# Generals on Storage Systems and Comments on J2579 (5.2.2.1)

Hydrogen Fuel Cell Vehicle (HFCV)  
4th Meeting of the Subgroup on Safety (SGS)  
Tokyo  
24<sup>th</sup> - 26<sup>th</sup> September 2008

Georg W. Mair  
BAM-III.2

## 5.2.2.1 “Extr. temp. gas cycle test”

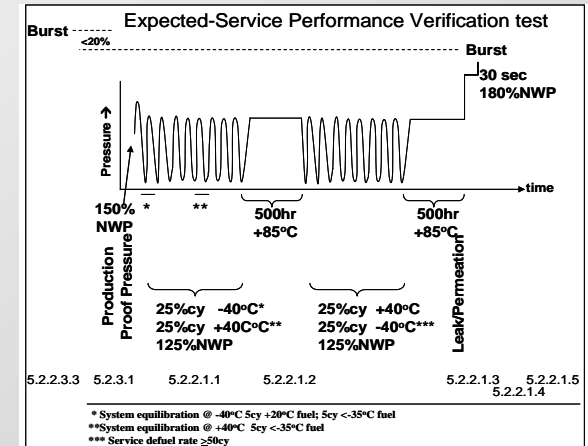
This test concept can be supported as best method for simulation the composite degradation process during use, if the following questions can be affirmed:

1. Is the filling procedure at fuelling stations harmonised enough to enable a description of test parameters such that the most critical degradation aspects are covered?
2. Does the ultimate criteria of 180% of NWP cover reliably the specific scatter of UTS of all cylinders with CFRP or other fibres?
3. How to ensure that one specimen can present the behaviour of all containers?
4. How to prevent a sudden burst during gas cycling such that the test facilities can be built up like a hydraulic test facility?

## 5.2.2.1 “Extr. temp. gas cycle test”

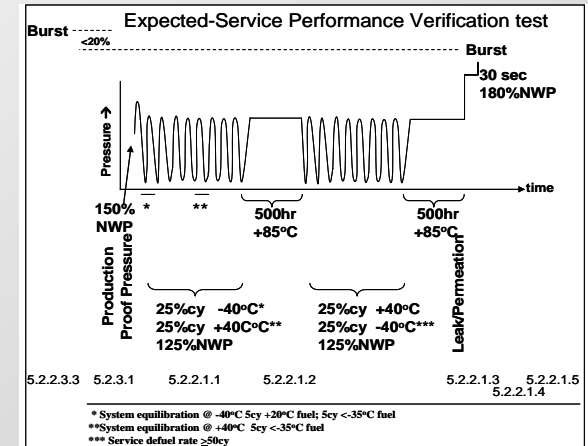
This test concept seems to be the best method to simulate the composite degradation process during use. But....

6. ... the test is extreme expensive to be performed on an adequate number of samples or to be repeated periodically during production.
7. ... the necessary test equipment (extreme ambient temperatures during filling procedure gas cycling) is commercially not available in an adequate number.
8. ... the concept of final burst tests in general may be appropriate for type IV-cylinders; It is not sufficient for cylinders with load sharing liners. At those the remaining strength of fatigue strength (scatter of cycles) or a critical change of residual stresses can not be detected.

## Excerpt of StorHy Life Cycle Tests at BAM ( $p_{\max} = \text{MAWP}$ )

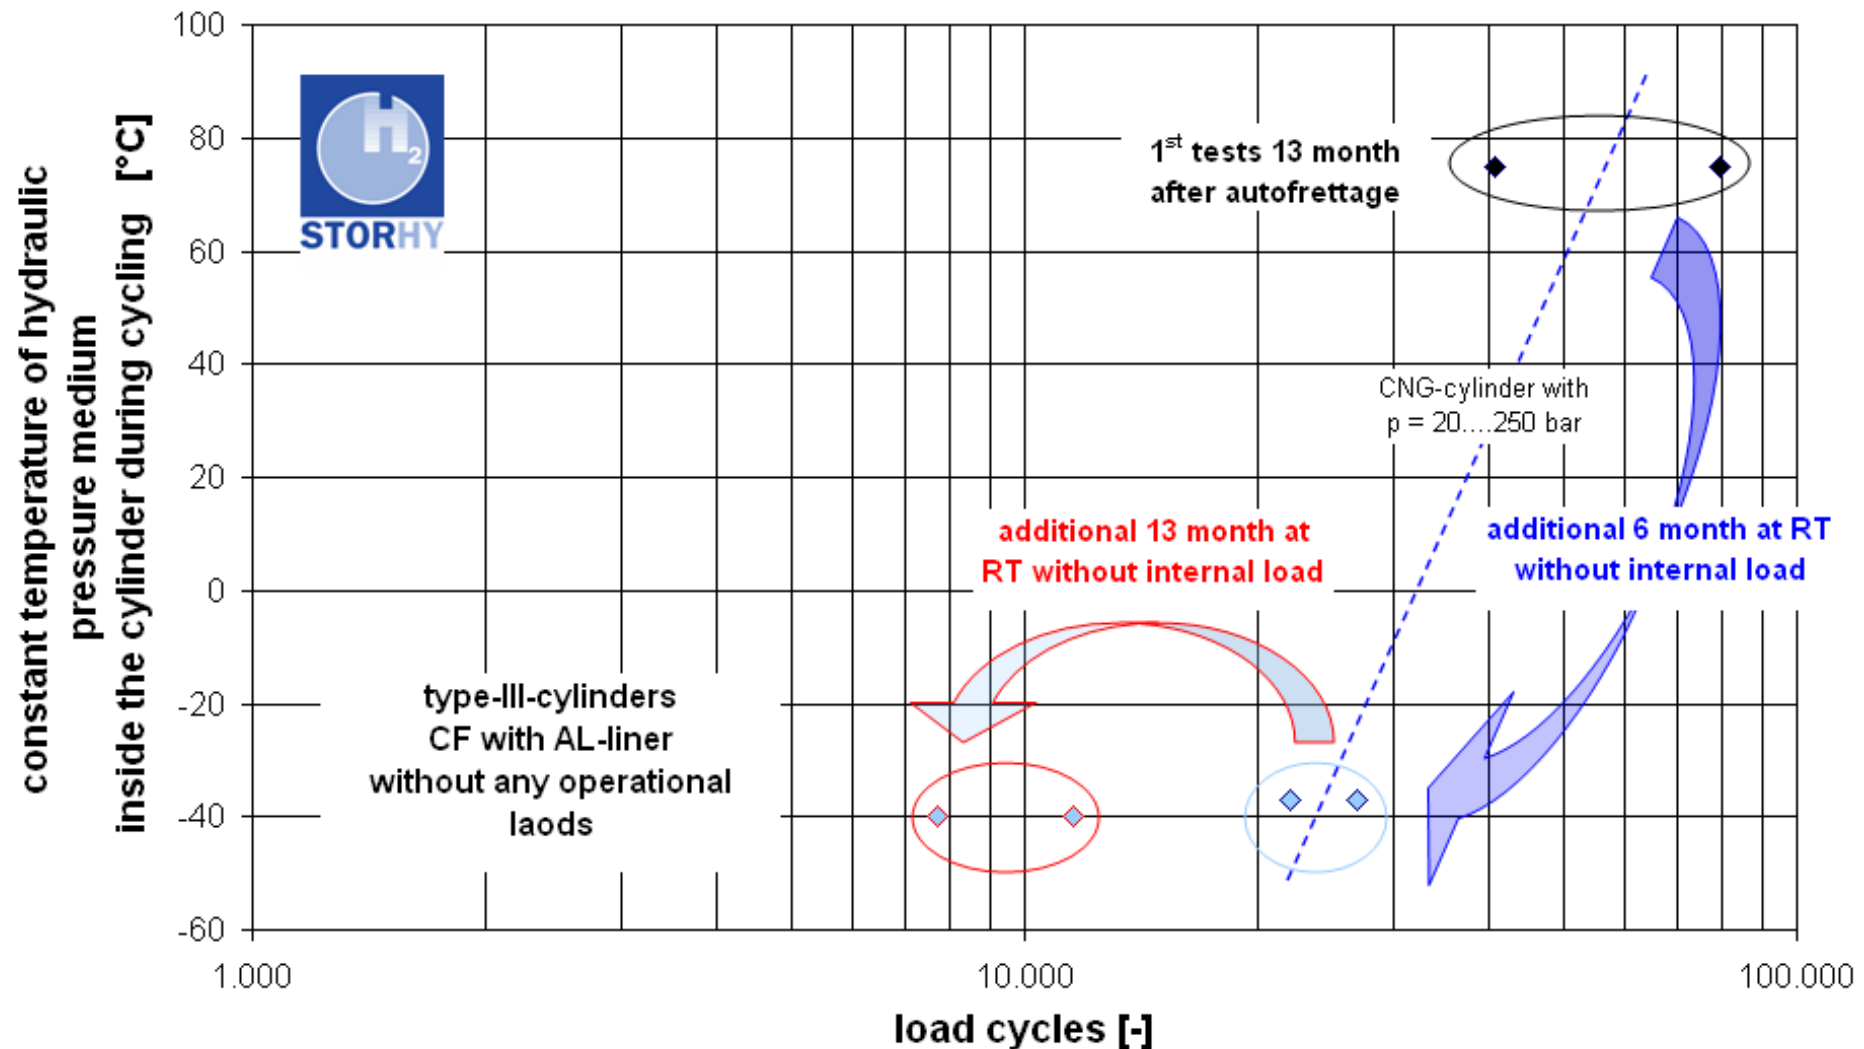
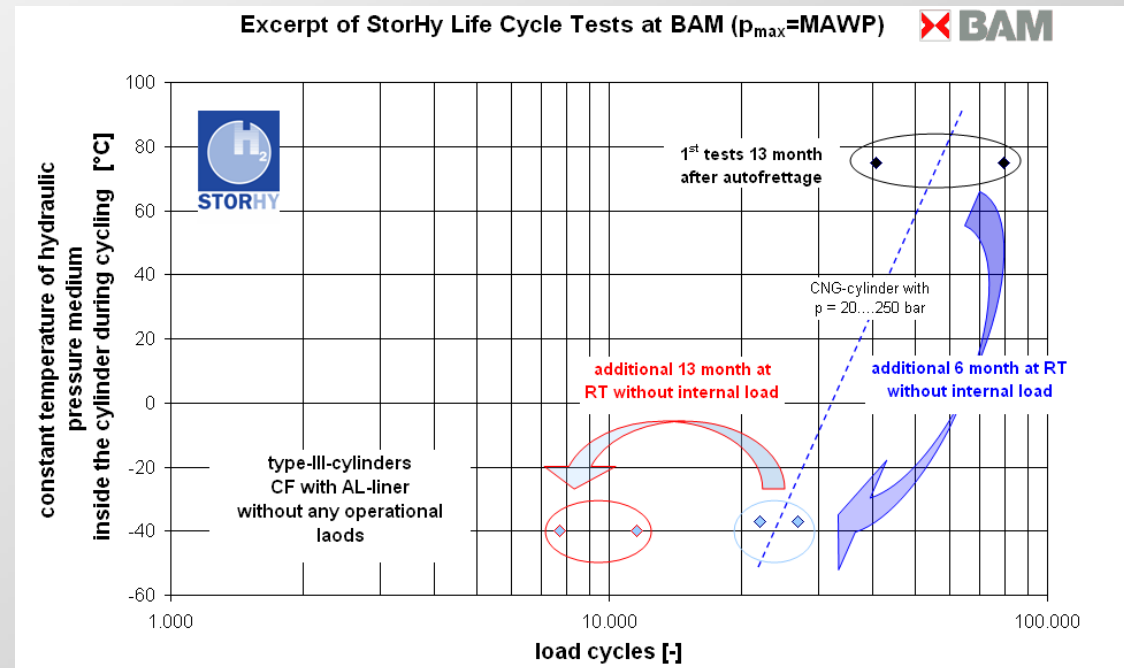
## These test results show ...

- ... a significant influence of the **temperature** during cycles.
- ... unexpected influence of the **storage time** before cycling.

But it is currently not possible to confirm that the conclusion on the first view (it looks like a strong degradation of fatigue life without any pressure loads) is correct!

But we should have a stronger look on the long term impacts on **residual stresses and consequences** .....

**Exemplary calculation of a type-III-cylinder for CNG with CRP and A6061T6**

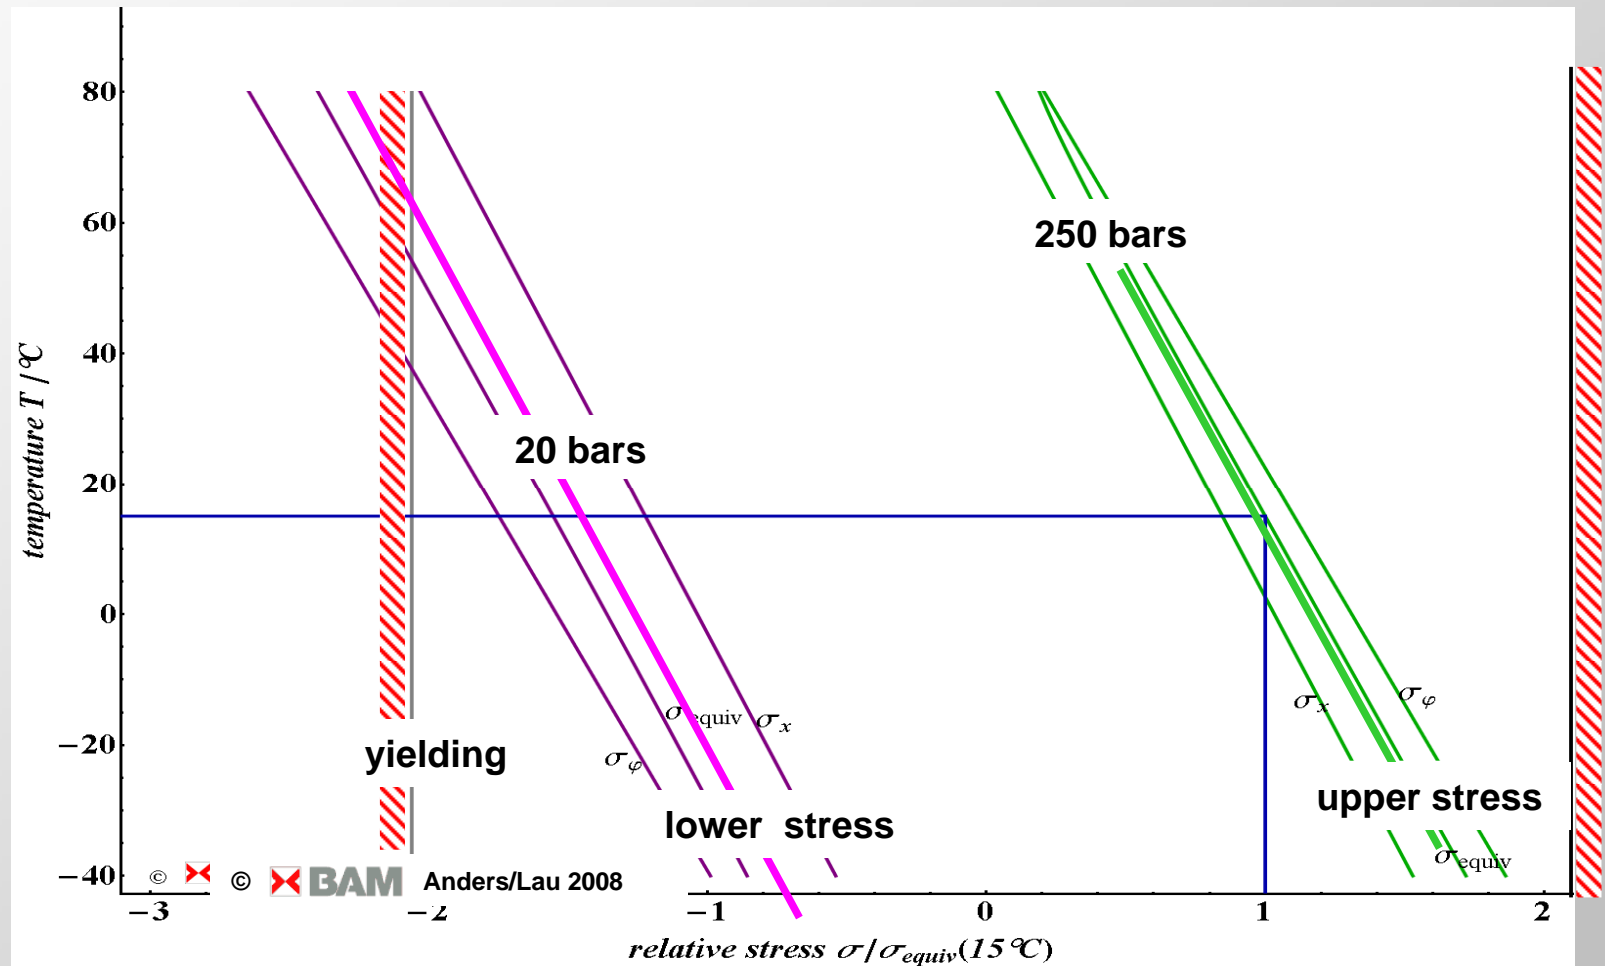
The upper and the lower stress levels (v. Mises) of a load sharing liner depends on temperature more than mostly estimated today.
